NEW MEXICO ENVIRONMENT DEPARTMENT

MEMORANDUM

Subject: NMED Comments, American Minerals, Inc. Deming Jigging Plant, Request to Change Post Mining Land Use, Luna County, New Mexico,

MMD Permit No. LU001RE, Modification 18-1

Repeat photo from November 2018. Note additional course grained material placed to armor aeolian sand deposits.

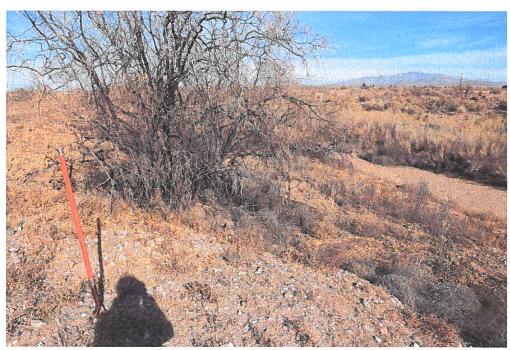
Photo from November 2017, looking across the site from the north. Road on the right marks the western boundary of the reclaimed facility.
